Japan Comments for Battery Durability GTR EVE39

4.November.2020

Families Definition (quoted from EVE38-15e)

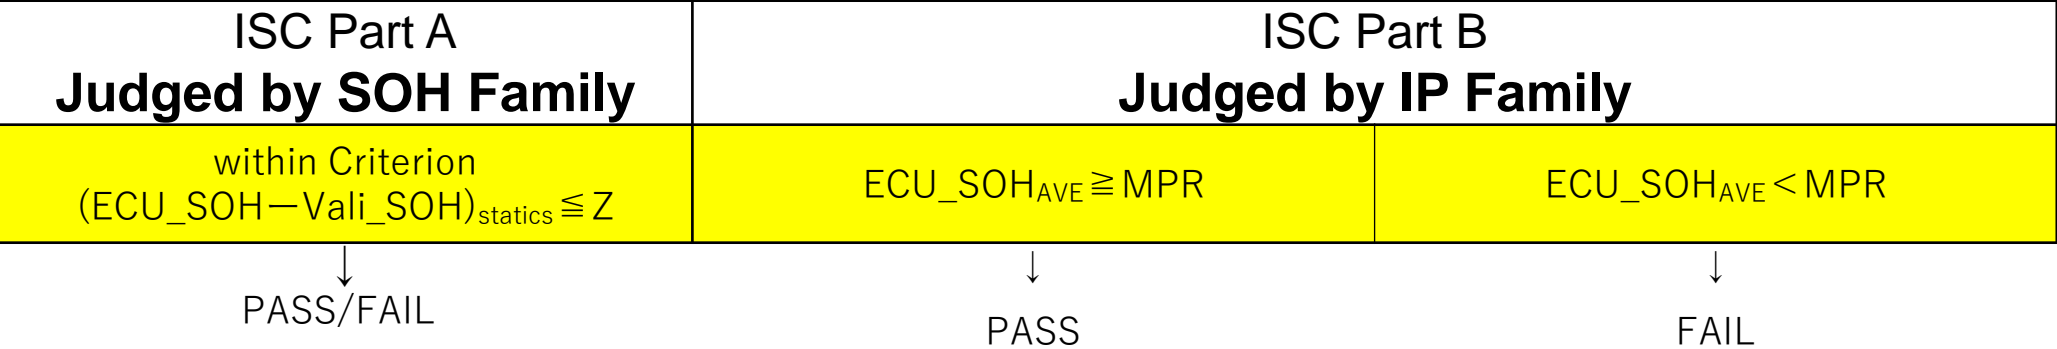
Two conditions are added to the GTR draft (Next Page), but (c) is included in (b) and (d) is a vehicle selection condition and not an IP family definition. It is recognized that the IP family was defined in GTR 15 including these battery requirements, and the necessity of adding these conditions is now unknown.

1-3.Family Usage for ISC Part A, Part B

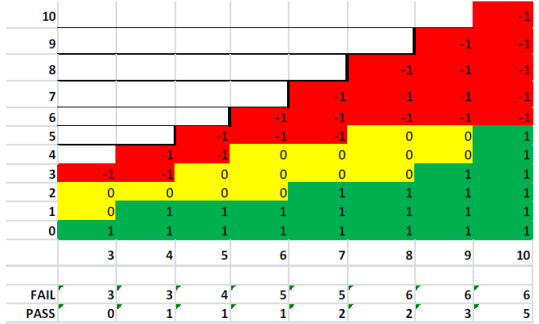
- 1.To achieve a good balance between robust evaluation and test burden, by defining appropriate families to be tested .
- 2.Market measures based on ISC Part B to be effectively implemented avoiding unnecessary market disruption .
- 3.For ISC Part A, a wide range of vehicle selection based on the IP Family/mileage within the SOH Family can be possible (next page).

4.The verification of the SOH algorithm will continue even during ISC Part B. Part A is conducted every two years for each SOH Family as defined in figure on the right.

2. SOH _ Capacity and SOH _ Range

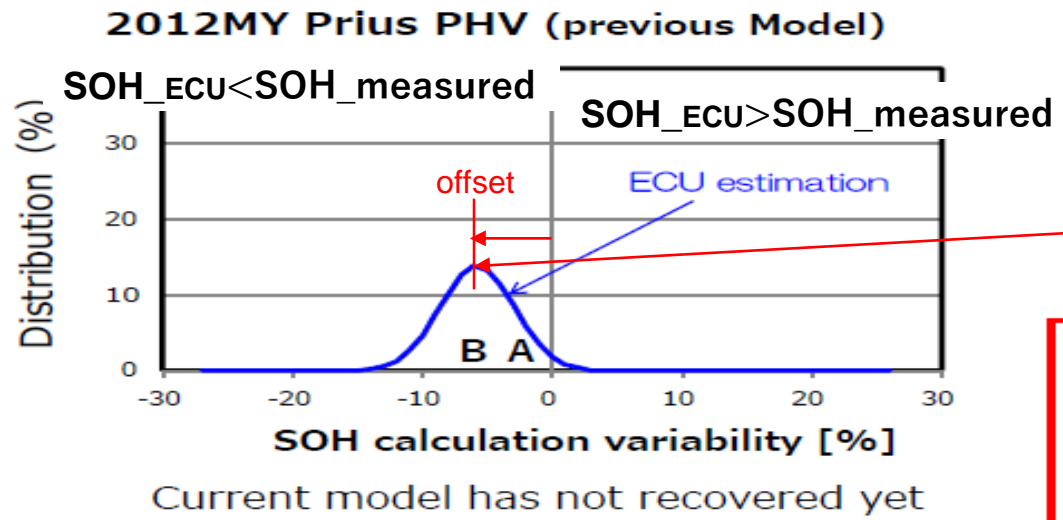
Japan can agree on the following directions discussed in the previous EVE.

- 1) In Phase 1, ISC Part A/B will be conducted only with SOH_Capacity and SOH_Range will only be monitored.
- 2) For the SOH Range in Phase 2, MPR etc. will be determined based on the monitoring results in Phase 1.
